STAFF RECOMMENDATION

312 South 11th Street

February 17, 2021

Application: New Construction—Addition; Setback Determination

Figures 2 & 3 show the right-side door and window configuration.

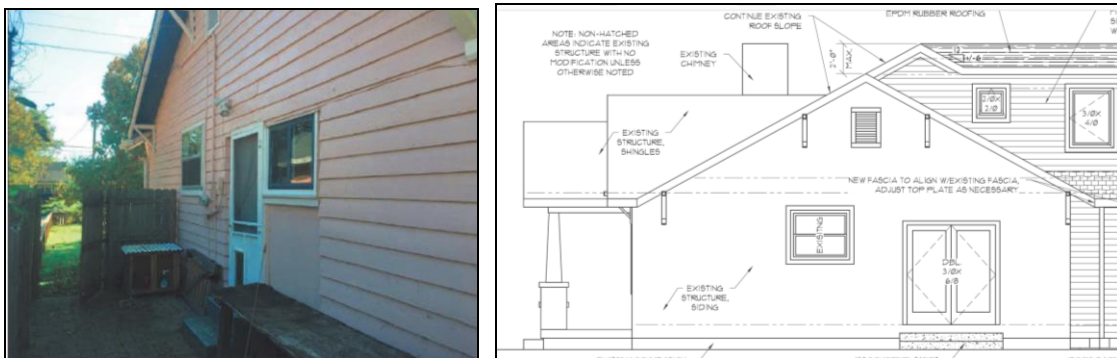
Partial Demolition. The applicant proposes to create a double door opening on the right side of the house, towards the rear, which is considered partial demolition (Figures 2 & 3). In most cases, staff finds that the creation of a double door opening on a side façade is not appropriate because that large of an opening was not seen historically on most side façades. Staff, however, finds the new opening to be appropriate in this instance because of the existing conditions on the house. The existing side façade has a door with a window directly next to it. The materials under this window have been replaced, and from the existing conditions, it appears that this used to be a door opening. For this reason and because the opening is in the back half of the side façade, staff finds creating a double door opening in this location to meet the design guidelines.

Staff finds that the proposed window and door opening alterations to be appropriate demolition and to meet Section III.B.1. of the design guidelines.

01 SITE PLAN

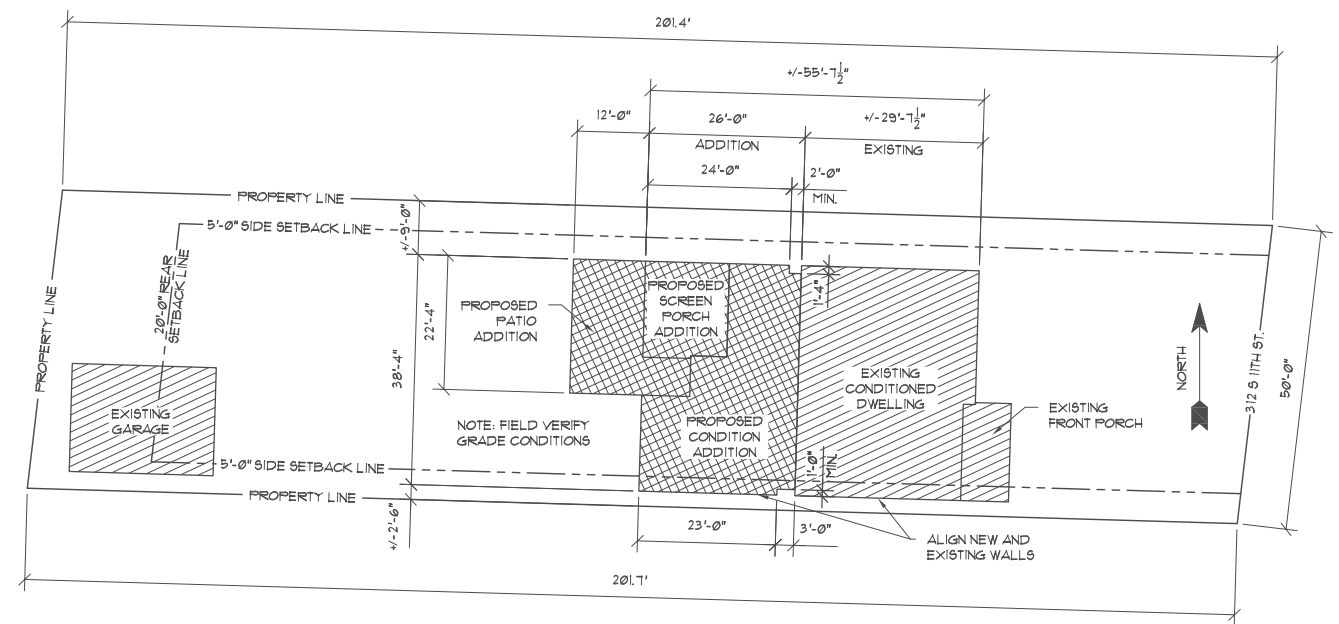
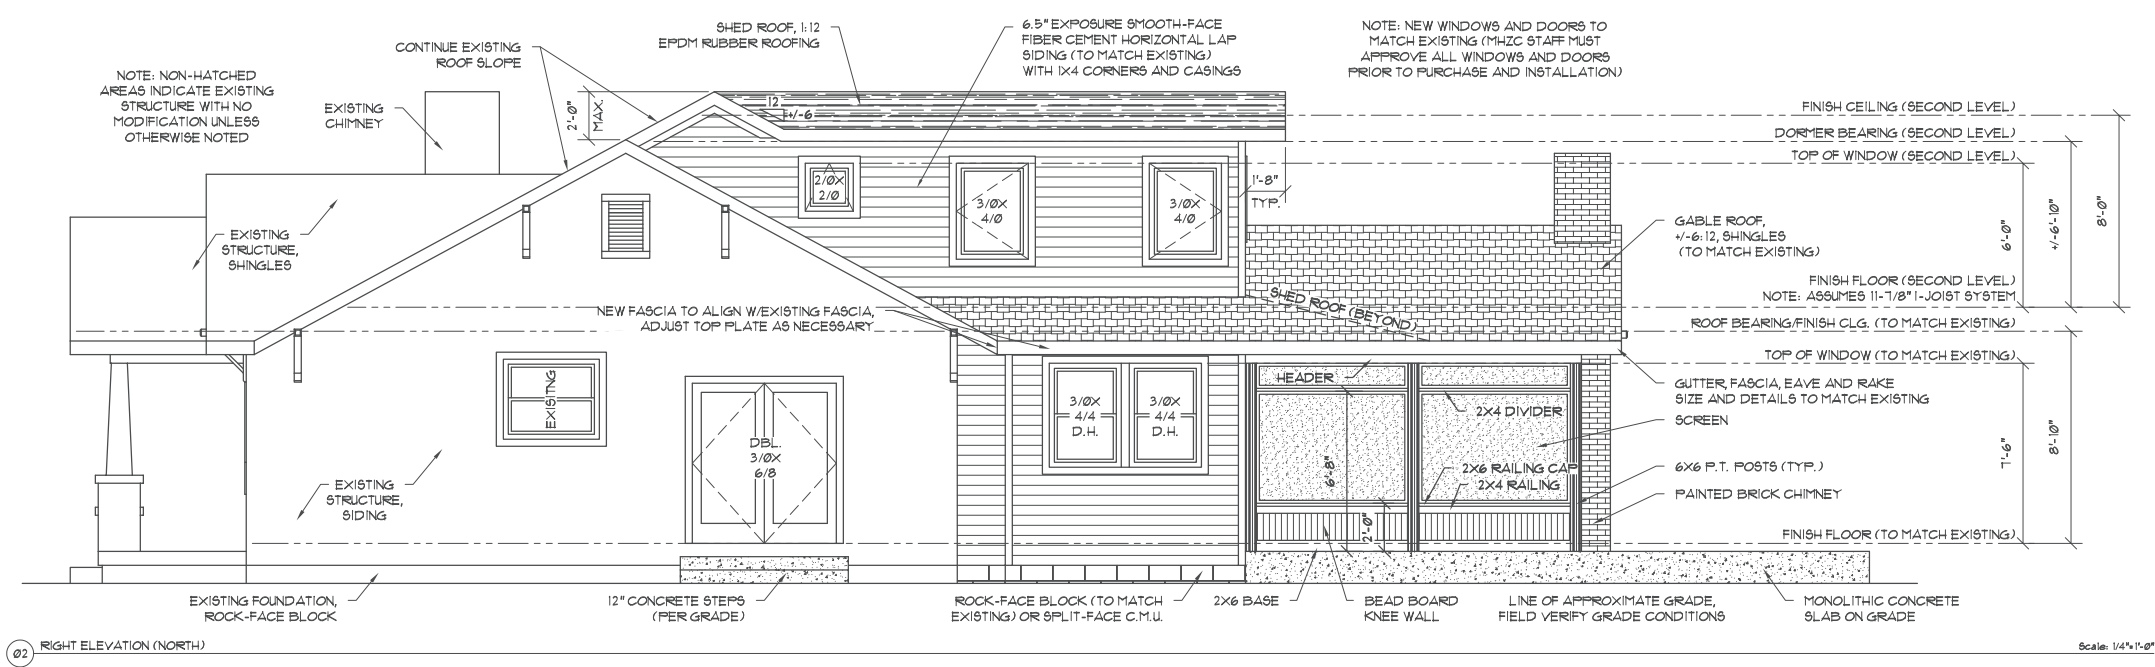
Setback & Rhythm of Spacing: The addition meets the base zoning setbacks on the right side and on the rear, but not on the left side. On the right, the addition is nine feet (9') from the side property line. The addition is about one hundred feet (100') from the rear property line. On the left side, the addition is just two feet, six inches (2'6") from the property line, which does not meet the base zoning setback of five feet (5'). Staff finds the setback of two feet, six inches (2'6") to meet the design guidelines because the existing house is also two feet, six inches (2'6") from the side property line and the

addition is no wider than the historic house. Also, the addition's depth of twenty-six feet (26') is appropriate and the addition is otherwise scaled to be compatible with the historic house and the neighborhood. Staff therefore finds that the proposed setbacks meet the design guidelines.

Staff finds that the addition's setbacks and rhythm of spacing to meet Sections II.B.3. and II.B.10. of the design guidelines.

EXTERIOR
 ELEVATIONS

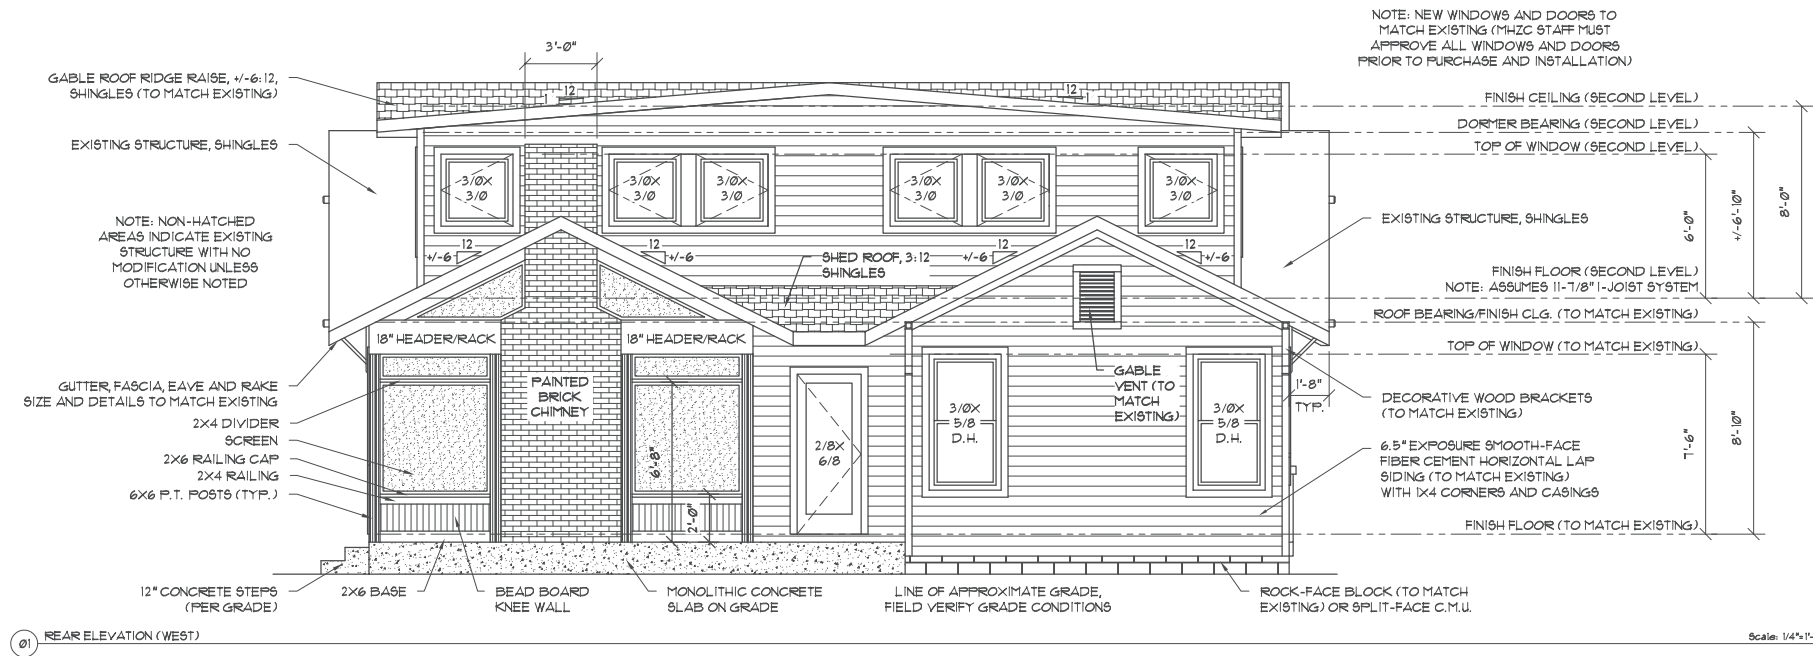
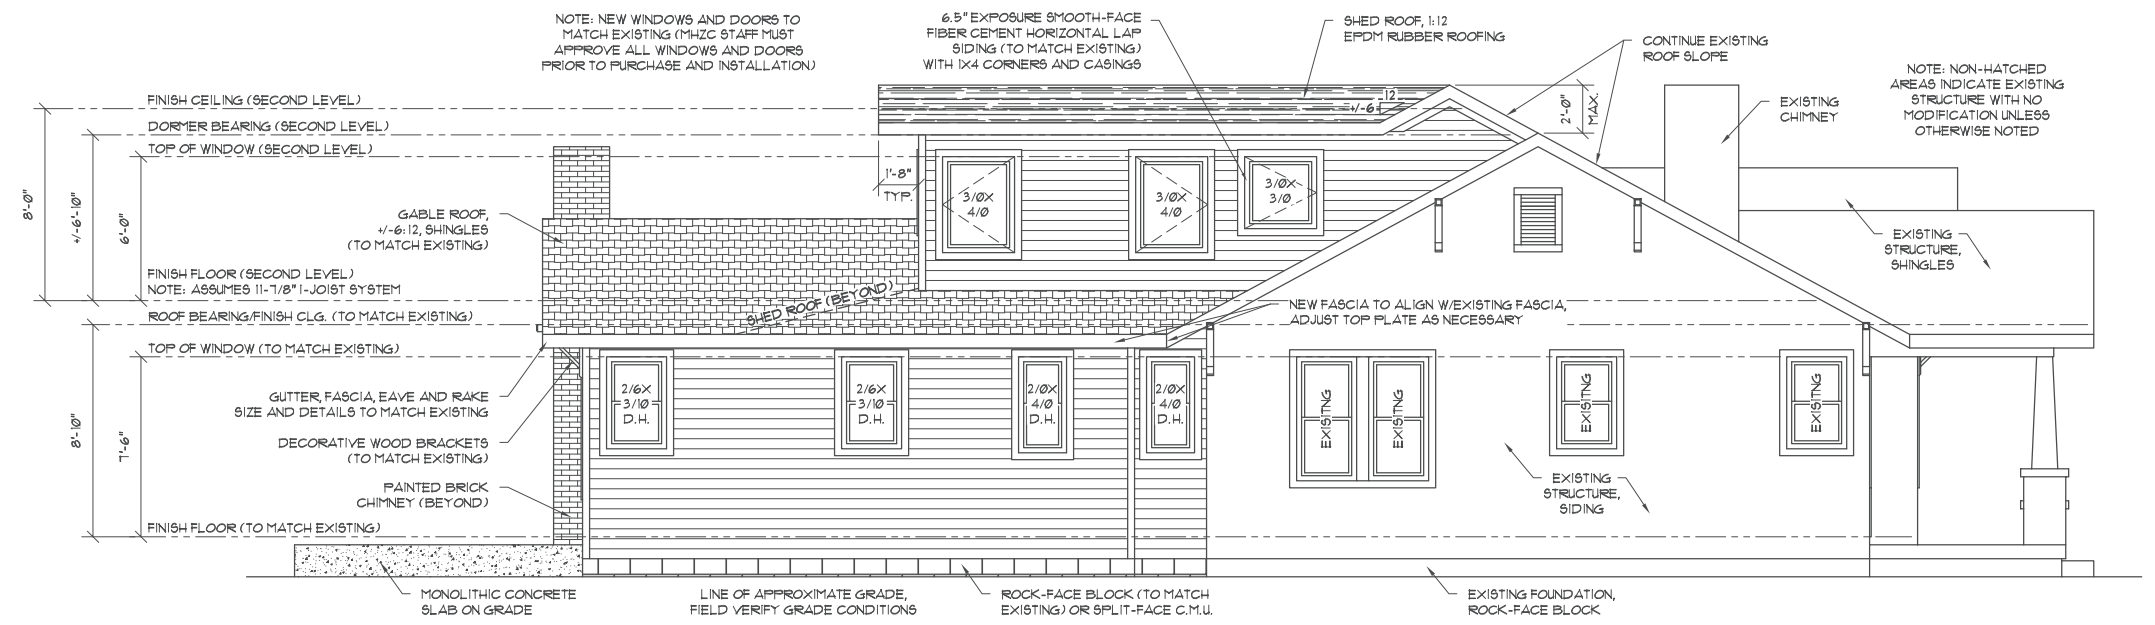
Height & Scale: The addition includes a two foot (2') ridge raise that is inset two feet (2') on both sides, per the design guidelines. On the ground floor, the addition insets one foot (1') for a depth of two feet (2') on the left side and three feet (3') on the right side, before stepping back out to line up with the side walls of the house. Staff finds this to meet the design guidelines. The second level of the addition is inset two feet (2') in its entirety. The addition will have a depth of twenty-six feet (26') and a footprint of approximately nine hundred and twenty-five square feet (925 sq. ft.), which is less than the house's historic footprint of approximately thirteen hundred square feet (1,300 sq. ft.) (Note, the project does not include removal of existing additions). Overall, the addition's height and scale is compatible with the historic house and the design guidelines.

Roof form: The addition includes a ridge raise that is inset two feet (2') on both sides and extends up two vertical feet (2'), per the design guidelines. The ground level's roof are 6/12 gables connected with a low shed. The dormers at the second level are low-sloped shed dormers. Staff finds that the addition's roof forms are compatible with the historic house's roof and meets Sections II.B.5. and II.B.10. of the design guidelines.

Proportion and Rhythm of Openings: The change to the window and door openings on the historic house are discussed under “Partial Demolition.” The windows on the proposed addition are all generally twice as tall as they are wide, thereby meeting the historic proportions of openings. There are no large expanses of wall space without a window or door opening. Staff finds the project’s proportion and rhythm of openings to meet Section II.B.7.
